Alton Coal Development, LLC

Subject: **Revised Diversion Ditch 1 and Sediment Impoundment 4, Task #4292, Coal Hollow Project, Kane County, Utah, C/025/0005**

Title: Revised Diversion Ditch 1 and Sediment Impoundment 4

Sediment Impoundment and
Diversion Structure Analysis

SEDIMENT IMPOUNDMENT 4 DETAILS

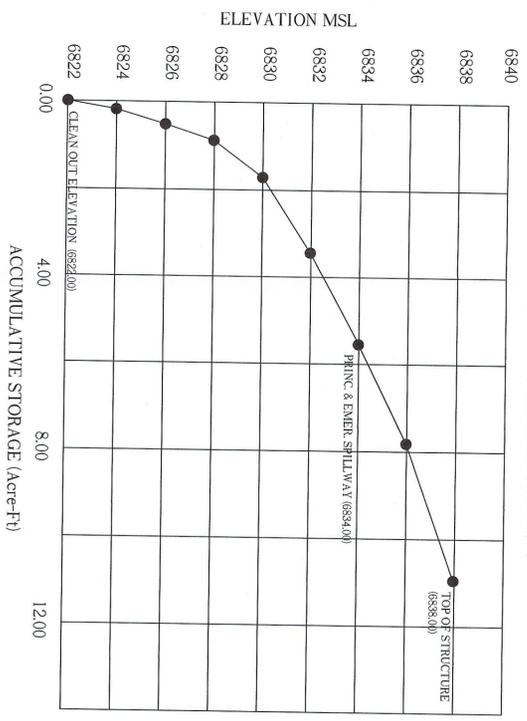
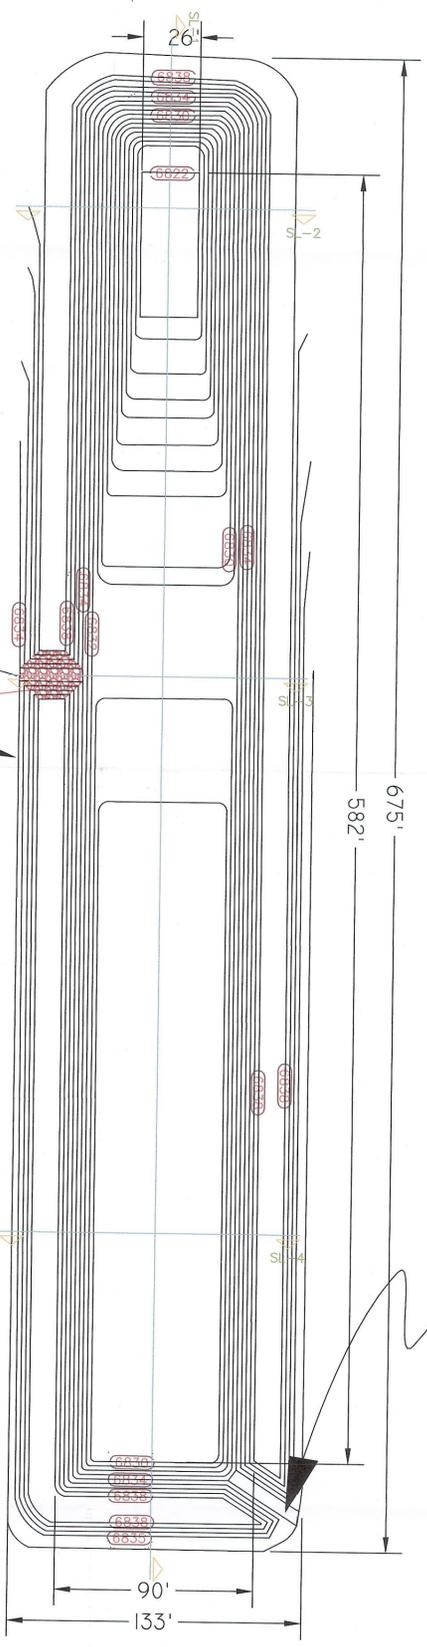
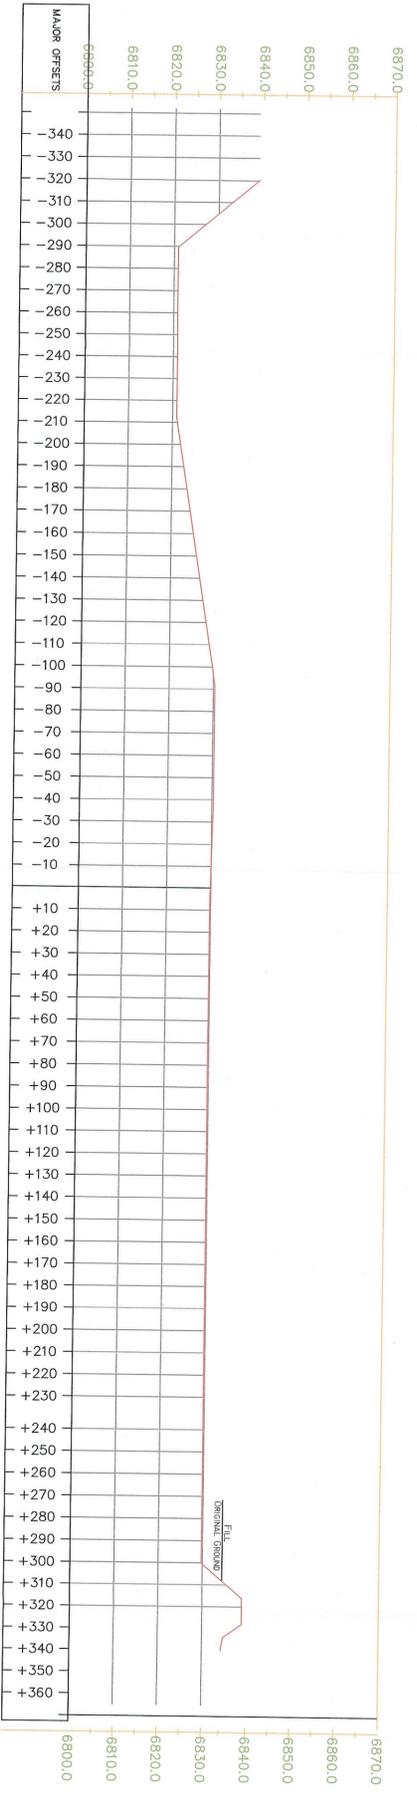
Structure 4 is a rectangular pond located at the south end of the permit area that is approximately ~~92-90~~ feet wide by ~~628-582~~ feet long and ~~11-12~~ feet deep. This impoundment will be incised into the existing ground. Part of the excavation will be used to construct a 12 foot wide embankment. The spillway will be an open channel that will have ~~vegetated slopes~~rip-rap min. 6". This pond will control storm water runoff from a watershed of approximately ~~256-96~~ acres. The cleanout and spillway elevation are ~~6823'~~6822' and 6834', respectively. Top of the embankment is at elevation 6838'. Details for the design can be viewed on Drawing 5-31.

Structure 4 is a rectangular pond located at the south end of the permit area that is approximately ~~92-90~~ feet wide by ~~628-582~~ feet long and ~~11-12~~ feet deep. This impoundment will be incised into the existing ground. Part of the excavation will be used to construct a 12 foot wide embankment. The spillway will be an open channel that will have ~~vegetated slopes~~ ~~rip-rap min. 6"~~. This pond will control storm water runoff from a watershed of approximately ~~256-96~~ acres. The cleanout and spillway elevation are ~~6823'~~ ~~6822'~~ and 6834', respectively. Top of the embankment is at elevation 6838'. Details for the design can be viewed on Drawing 5-31.

Required Storage for 100 year, 24 event = 2.1 acre/ft
Spillway at 6834'
RIPRAP 6" Ø (+)

DIVERSION DITCH 1 DETAILS

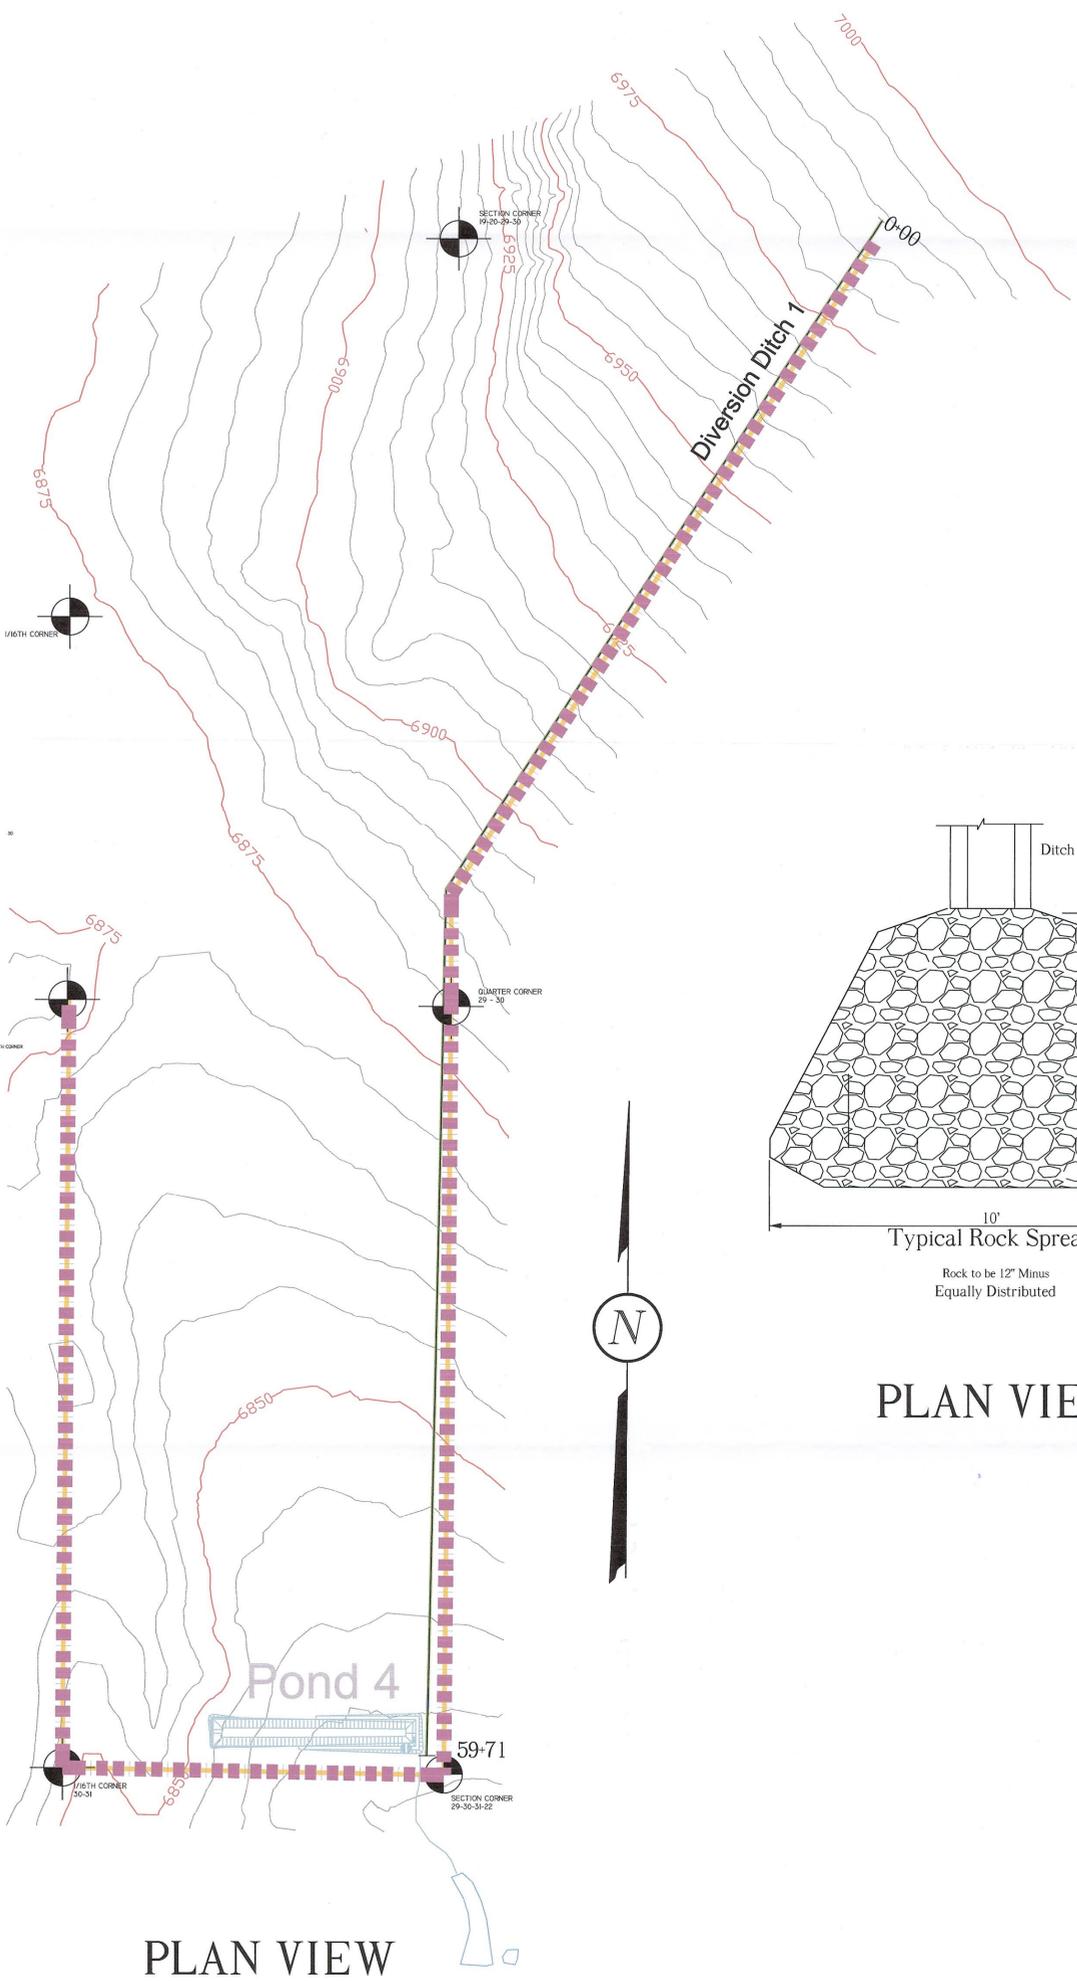
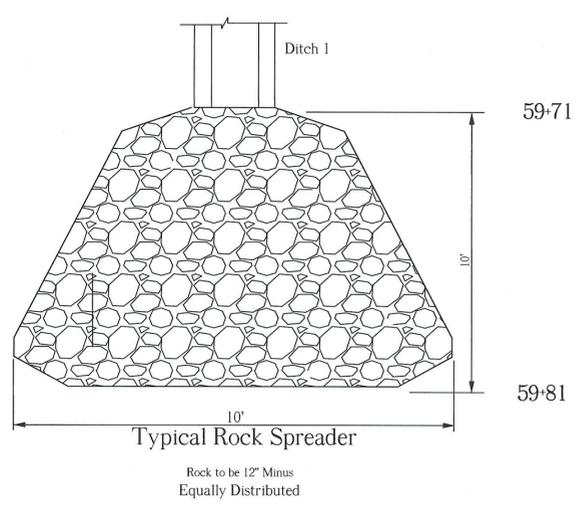
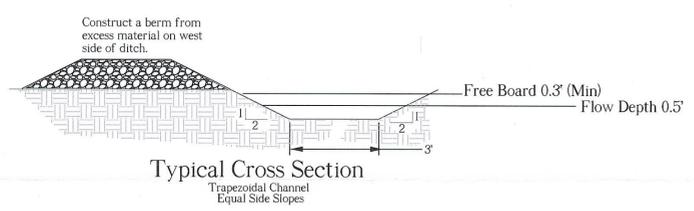
Alton Coal Development, LLC is providing this submittal to make minor revisions to Diversion Ditch 1(DD1) and Pond 4. DD1 is located on the Eastern side of the property up gradient of mining activities and its purpose is to divert uncontaminated surface runoff from adjacent undisturbed areas around the mining. The previously permitted design brought this uncontaminated water into Sediment Impoundment 4. This submitted design allows the uncontaminated water to bypass pond 4 and with the addition of an engineered rock spreader discharges the water beyond the mining activity. Sediment Impoundment 4 has been revised to reflect the absence of an inlet from DD1 and to depict the addition of Rip Rap lining the outlet. Revisions have been made as per the deficiency list in task #4292.
